Re: S/D 81-124 - Preliminary plat of Comotara Elementary School
Addition

PROJECT COMOTARA ELEMENTARY
SCHOOL ADDN. JOB NO. _____
TO CHRIS BREITENSTEIN
FROM N. B. WOOTEN
REFERENCE FINAL DRAINAGE PLAN

Re: S/D 81-124 - Final plat of Comotara Elementary School Addition
Gentlemen:

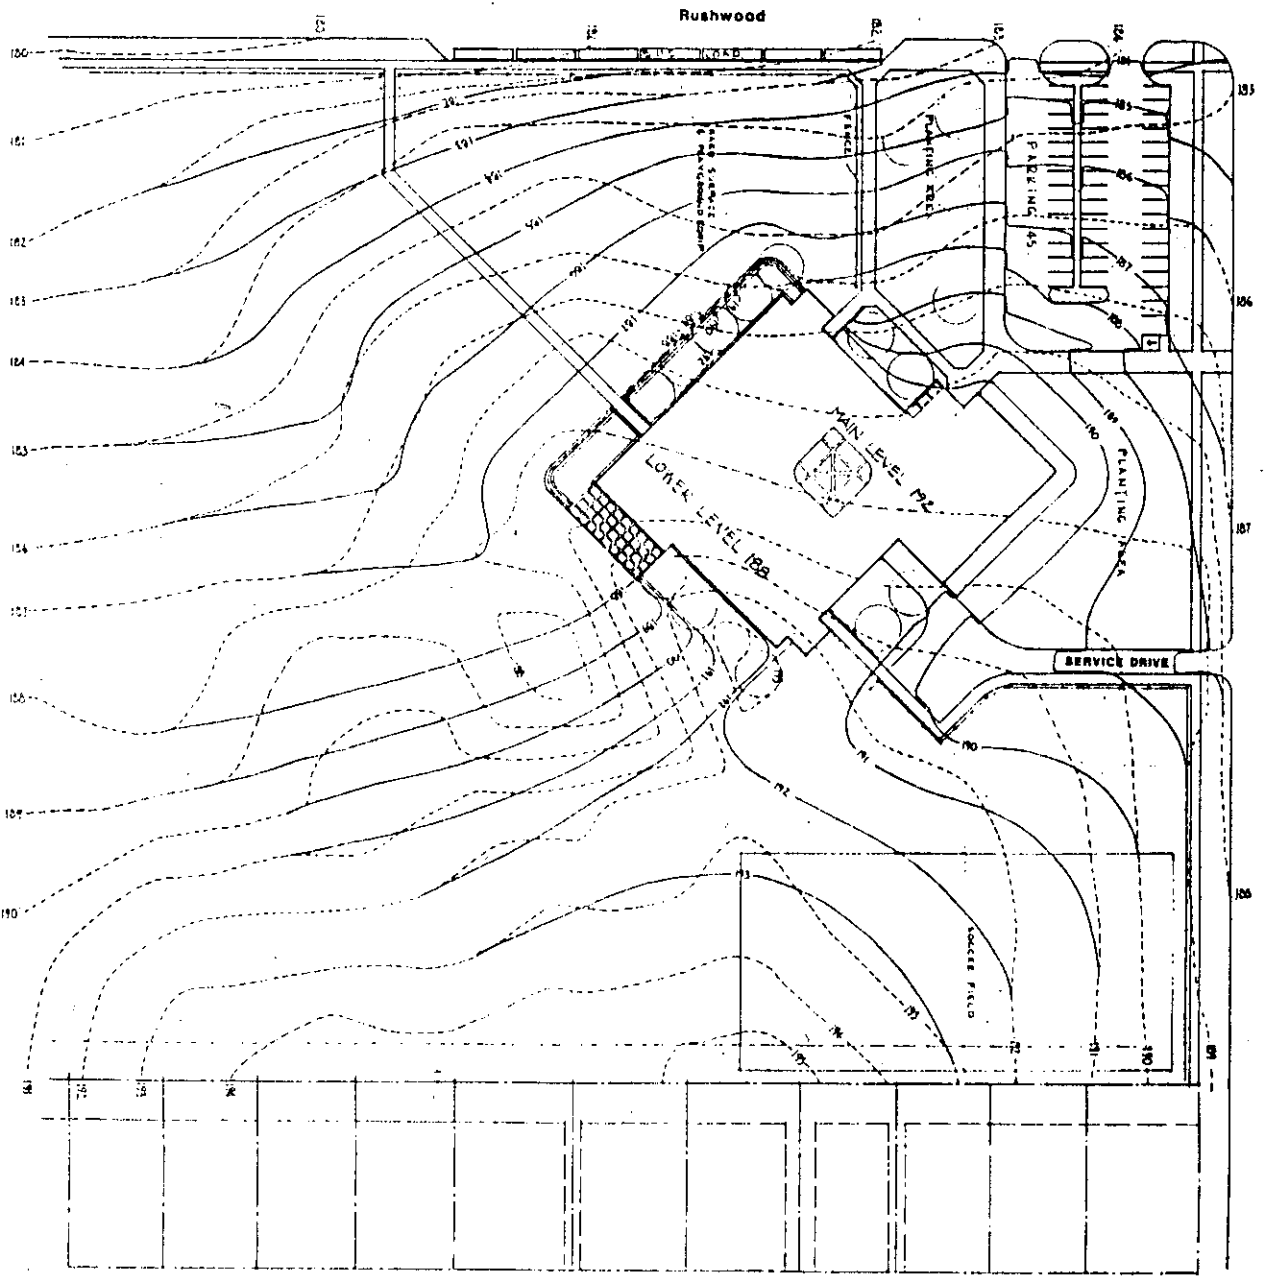
- A. The plattor's text shall be revised to state that plans for the service entrance from 32nd Street must be reviewed and approved by the City Engineer.
- B. The applicant shall submit a notarized sidewalk certificate which states that a sidewalk will be installed when the property is developed.
- C. Recording of the plat within 30 days after approval by the Board of City Commissioners.
